August 19, 2011

Subject: Response to Comments
Evaluation of Liquefaction Potential
Structures EP361, EP362-1 and EP363-1
SDG&E Sunrise Powerlink Project
San Diego and Imperial Counties, California
URS Project No. 27661032.01001

URS Corporation (URS) previously provided an evaluation of liquefaction potential at structures EP361, EP362-1 and EP363-1 in a letter dated May 17, 2011 (attached to this letter for reference). A review of that letter was performed by Geotechnical Consultants, Inc. (GTC) for the California Public Utilities Commission (CPUC), and their comments were provided in a memorandum dated August 3, 2011. The discussion below and attachments present the additional supporting documentation requested by GTC.

Figure 134. Atterberg limits chart, showing representative values for each soil that exhibited cohesive, cohesionless, or intermediate behavior.

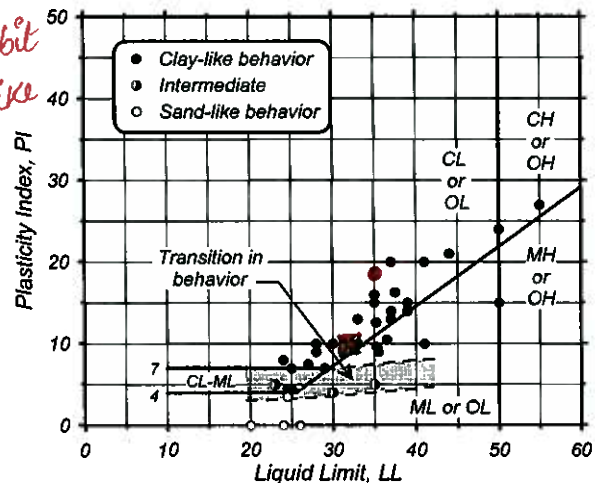
This report adequately covers the requirements of Mitigation Measure G-4b (Conduct geotechnical investigations for liquefaction) in relationship to structures EP361, EP362-1, and EP363-1. Although this document satisfies the intent of Mitigation Measure G-4b, it only included a very brief statement of the results of URS's liquefaction analyses without any supporting documentation of their calculations.

For B-EP361, a screening evaluation was performed by comparing the laboratory test data to evaluation criteria that relates potential behavior to index properties. The evaluation was performed using the EERI Monograph "Soil Liquefaction During Earthquakes" (Idriss and Boulanger, 2008). Screening evaluations indicate that the fine-grained soils encountered in the boring should exhibit clay-like behavior and should not be susceptible to liquefaction-type behavior or strength loss. A copy of the pertinent pages from this reference is attached.

B-EP361 Sample @ 40.0'
 B-EP361 Sample @ 15.5'
